Entergy Nuclear Generation Co.
Pilgrim Nuclear Power Station
600 Rocky Hill Road
Plymouth, MA 02360

February 2, 2001
ENGCLtr. 2.01.015

**MODIFICATION OF TECHNICAL SPECIFICATION CHANGE SUBMITTAL
CONCERNING PRESSURE-TEMPERATURE LIMIT CURVES**

PILGRIM REACTOR VESSEL PRESSURE-TEMPERATURE LIMITS
HYDROSTATIC AND LEAK TESTS

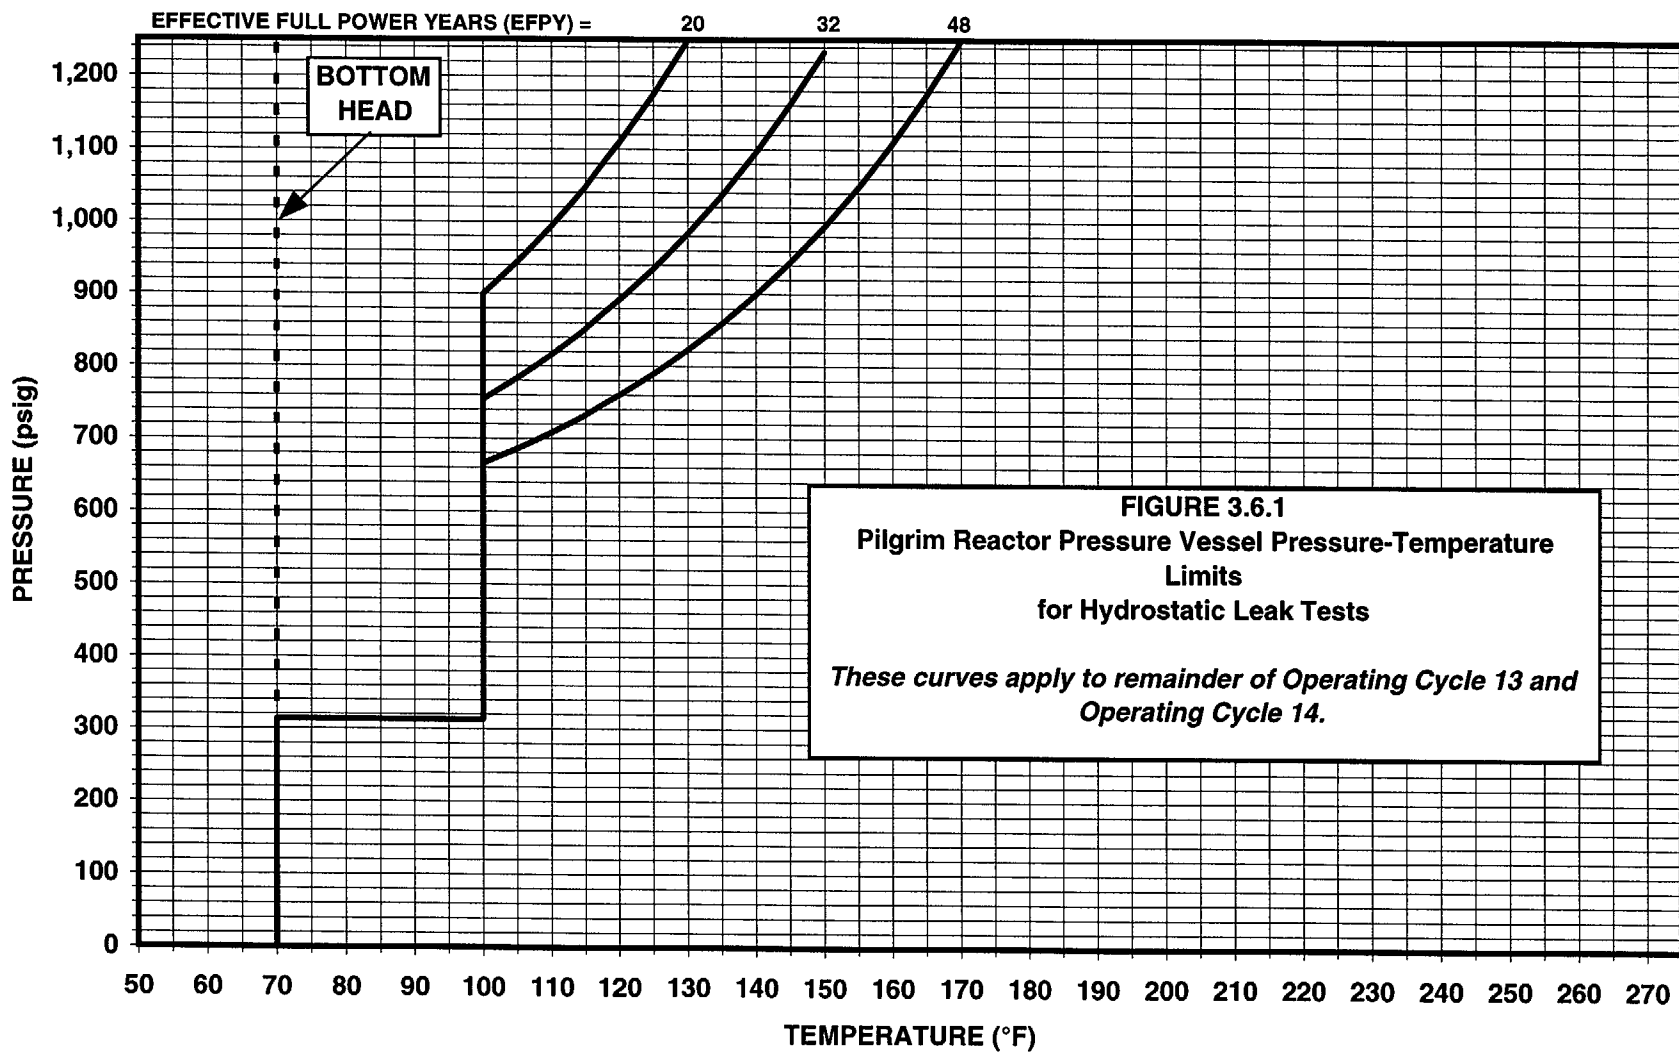
This proposed change to Pilgrim's November 22, 2000, amendment request adds a footnote to Figures 3.6.1, 3.6.2, and 3.6.3 of Pilgrim's Technical Specifications that states:

These curves apply to remainder of Operating Cycle 13 and Operating Cycle 14.

During NRC review of the amendment request, Pilgrim learned that a new methodology for calculating neutron fluence was soon to be approved by the NRC for industry use. The November 22, 2000, amendment request curves used an approved fluence methodology that may be superseded by the new methodology. Pilgrim, therefore, is amending the November 22, 2000, amendment request by limiting application of the proposed curves to essentially one cycle, that is, the remainder of operating cycle 13 and operating cycle 14. Operating cycle 13 is nearly over; operating cycle 14 is scheduled to commence at the conclusion of refueling outage 13, currently scheduled for May, 2001.
